Emanate Wireless, Inc.

Request for Class II Permissive Change

About our product: Emanate PowerPath Tag, FCC ID: 2AEWLPPT-200, we want apply Class II permissive change, and the difference between old product and new product are as below:
There are identical as following:
RF module, Antenna, Enclosure, Internal structure. There are no RF parameter changes to the operating frequency band, rated radiated and conducted output power of the device.
There are some changes in Electronic Components without RF module, please reference the new circuit schematic and below detail.

Power board

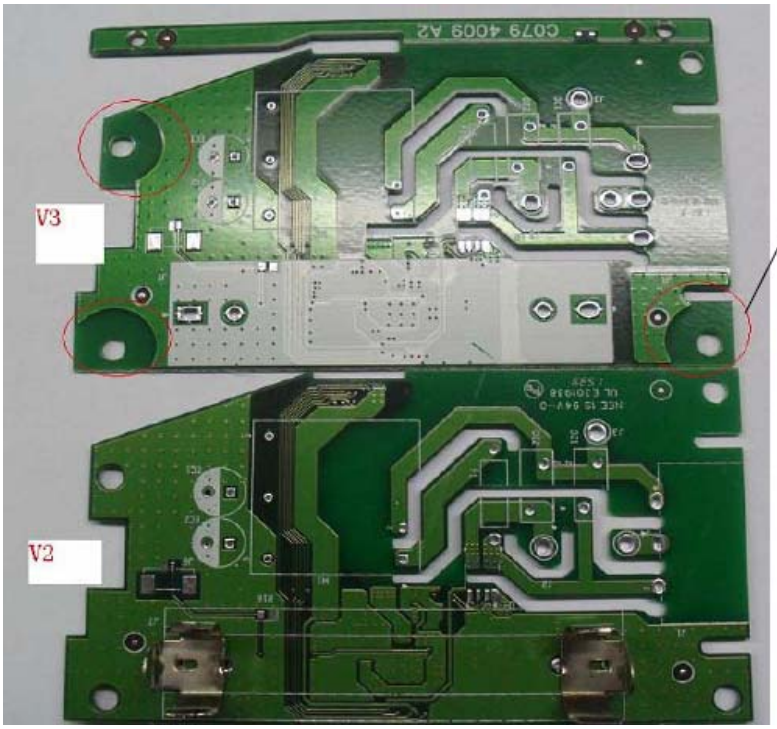
item	The difference of new product compared with old product	Remark
Limiter board	Power board : Change PCB layout, no change components, please refer to next page 2. Main board : Change PCB layout, deleteU2,IR1, R64,R65,R66,R67, R8,R9 ,R41-R44,R61,R99,R71,R72,C29-C34,C8,C9,Y1, LX1,LY1,J6, please refer to next page 3-4	/

the 4mm gap form copper foil of screw hole

The dfference between PPT-200V1 (original) and PPT-200 V2 &PPT V3 Power board

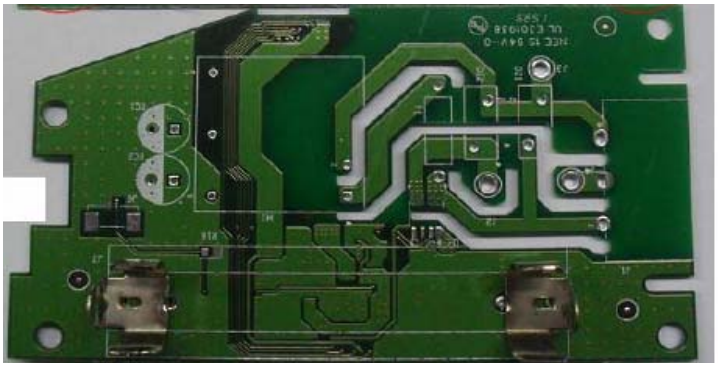
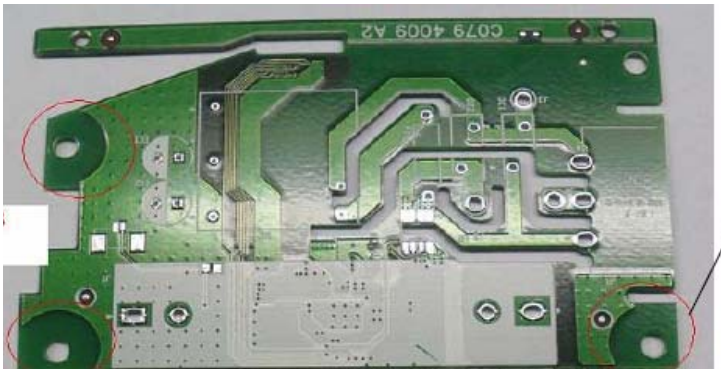
the 4mm gap form copper foil of screw hole
